From: Mark Reynolds <mreynolds@etv.net>
To: Wayne Hedberg <waynehedberg@utah.gov>, Joe Helfrich <joe Helfrich@utah.gov>, Jim Smith <jimsmith@utah.gov>, Steve Christensen <stevechristensen@utah.gov>, Pete Hess <petehess@utah.gov>
Date: 11/21/2006 12:36:06 PM
Subject: Federal Lease Addition

Attached is a copy of the response to the issues we identified during the telephone conference. The items are listed below

BEAR CANYON PLATE 5-3

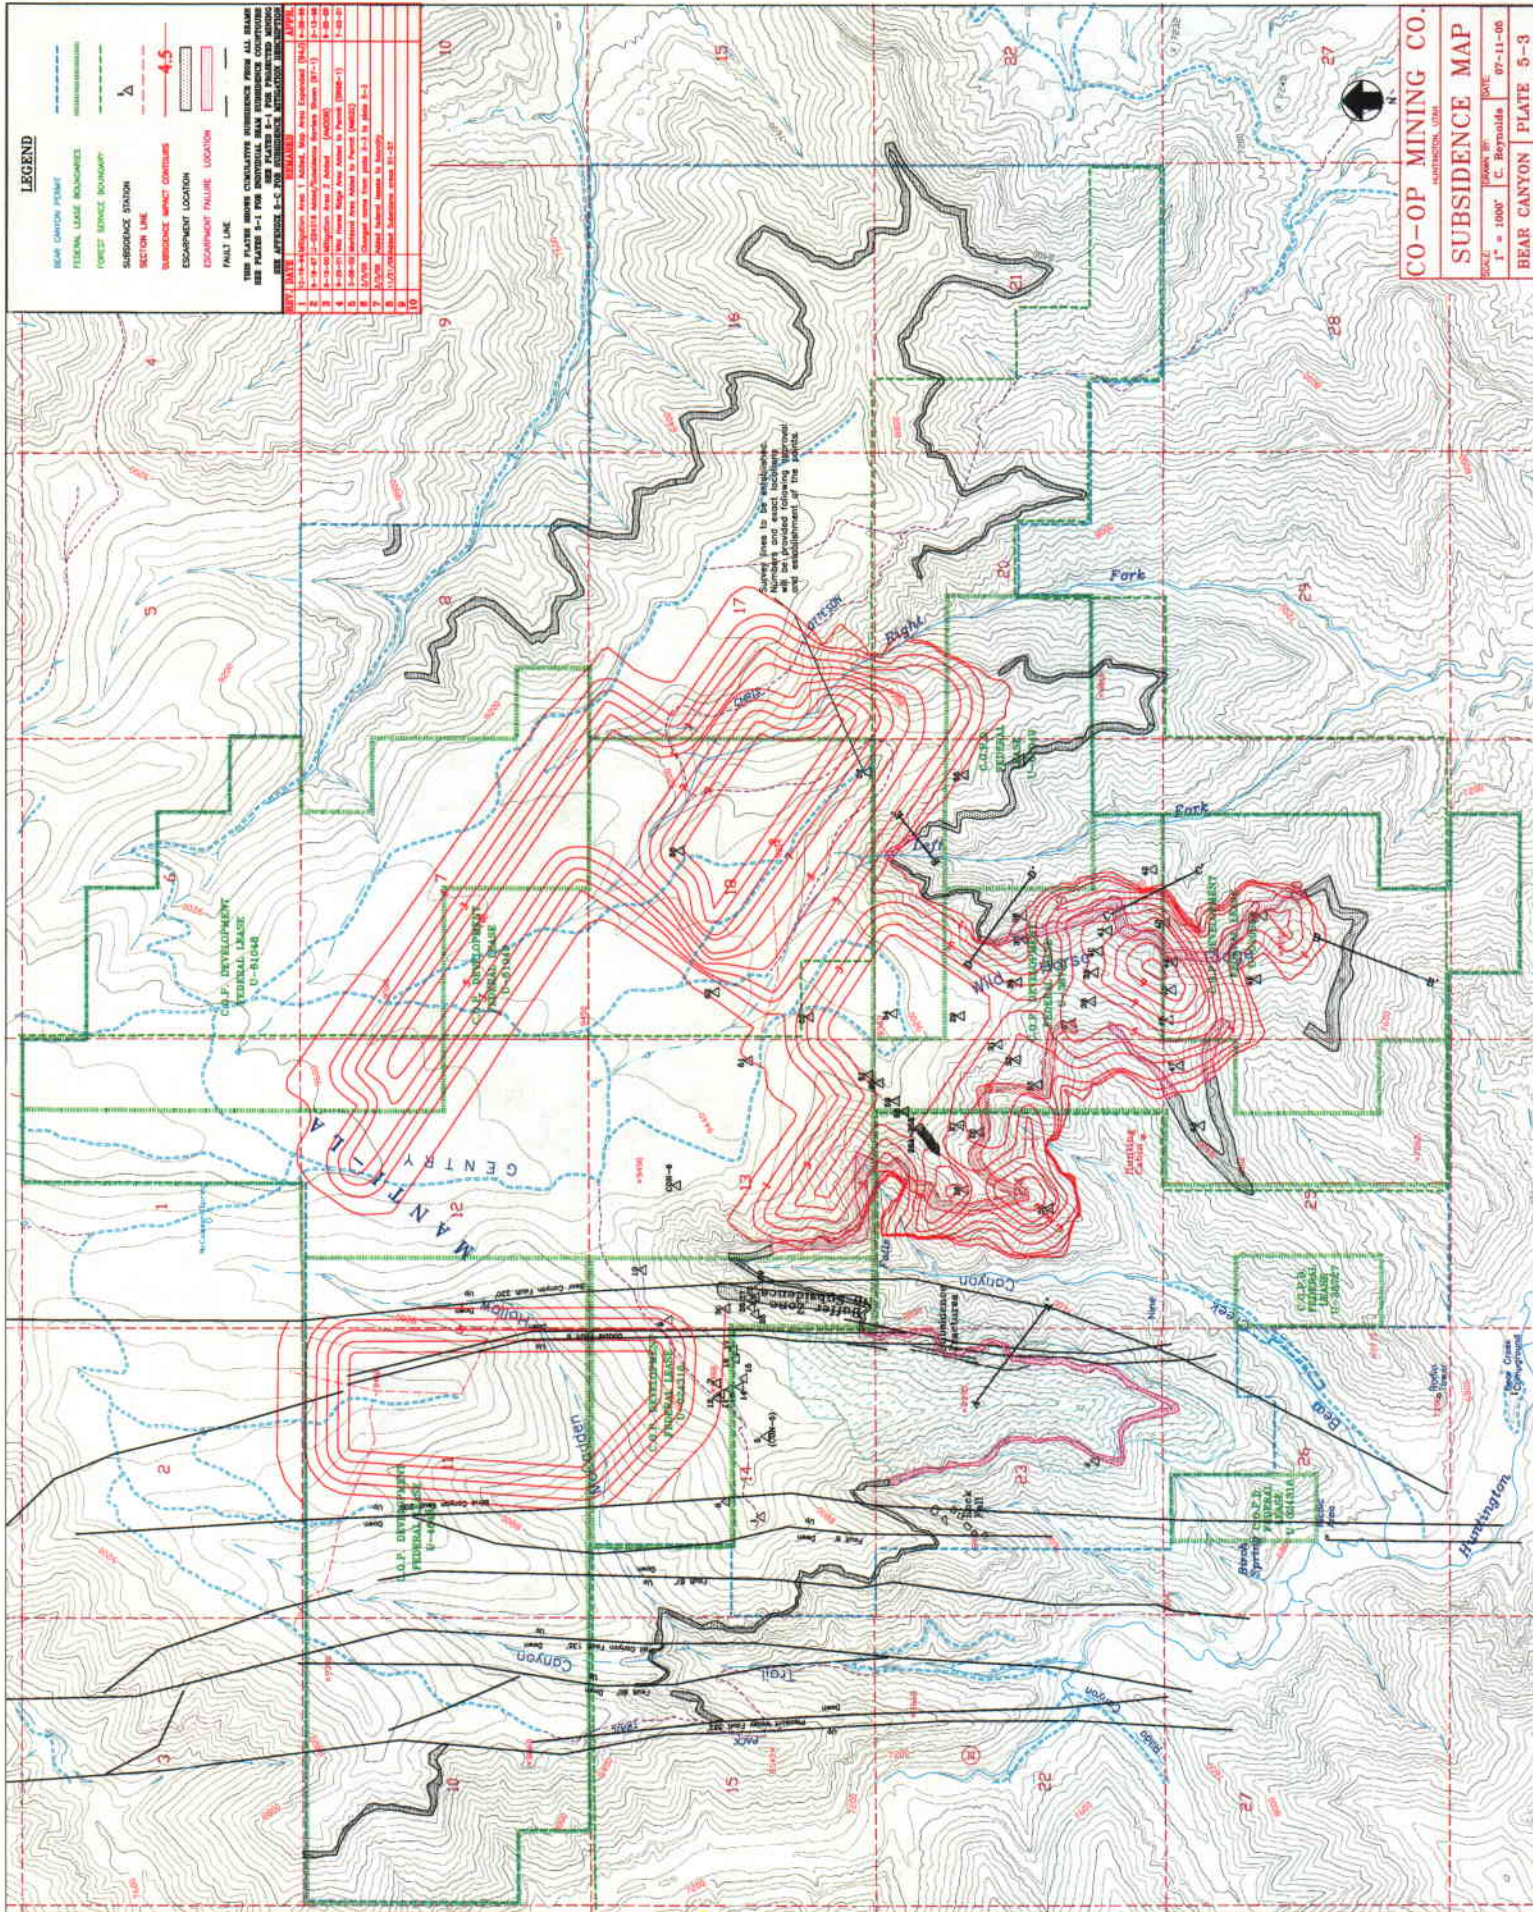
3. Update the streams on all maps to match 7-4. (This was done on Plate 5-3, 5-3A, and 7-12)
4. Send Betsy a current copy of all maps. (I never got her email address or mailing address. I am trying to get it from Dale.)
